ACCESSION NBR: 9809240042 DOC.DATE: 98/09/16 NOTARIZED: NO DOCKET #
 FACIL: 50-244 Robert Emmet Ginna Nuclear Plant, Unit 1, Rochester G 05000244
 AUTH.NAME: AUTHOR AFFILIATION
 MECREDY, R.C. Rochester Gas & Electric Corp.
 RECIP.NAME RECIPIENT AFFILIATION
 VISSING, G.S.

SUBJECT: Discusses leak detection sys in support of LBB application
 of portions of RHR sys at RE Ginna Nuclear Power Plant.
 Description of successful leak detection event that occurred
 on 980819, provided.

Subject: Discussion of Leak Detection System in Support of Leak-Before-Break (LBB)
Application of Portions of Residual Heat Removal (RHR) System (TAC No.
MA0389)
R. E. Ginna Nuclear Power Plant
Docket No. 50-244

TREND DISPLAY

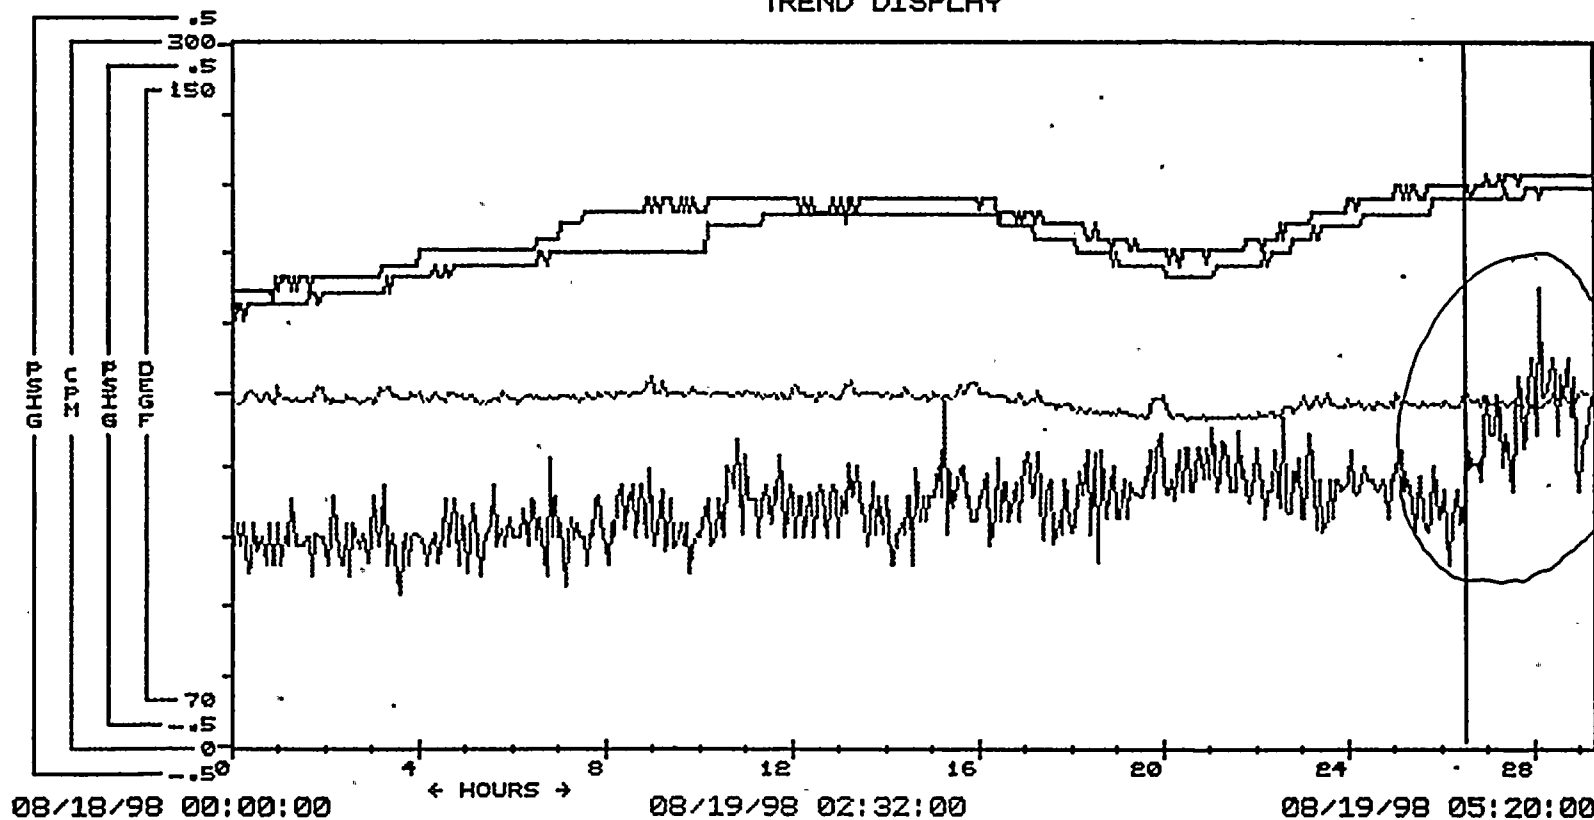
On August 19, 1998 at 2:30 AM, operations personnel noted a trend upward on R-11 response (see Attachment 1). Background readings for R-11 had varied from 90 cpm to 120 cpm, but by 5:30 AM, the count rate has increased and stabilized at 150 to 200 cpm. Analysis of a containment air sample showed radioisotopes of the types Na-24, Mo-99, and I-133, with a total concentration of $2.0\text{E}-11$ uCi/cc. The operators later pinpointed the leak at a vent connection on the Letdown piping with 2" nominal diameter. The leak was estimated to be from 0.05 - 0.10 gpm. In the past, there have been other instances where R-11 detector has indicated higher count rates and triggered a search using walkdowns or noting liquid inventory changes of RCS make-up system.
